# UNITED STATES PATENT AND TRADEMARK OFFICE

10/663,889

<b>Office Action Summary</b>	Application No. 10/663,889	Applicant(s) MCCLURE ET AL.	
	Examiner Justin M. Larson	Art Unit 3727

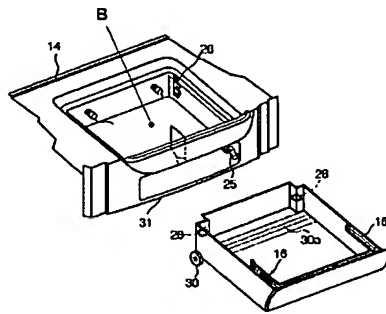
Regarding claim 4, the support member of Fukushima et al. includes an outwardly projecting protrusion (28) and the bottom portion (B, Figure below) of the shell includes an inwardly extending recess (26) adapted to receive the protrusion.

Regarding claim 18, the bottom portion (B, Figure above) of the shell of Fukushima et al. includes the recessed region (26).
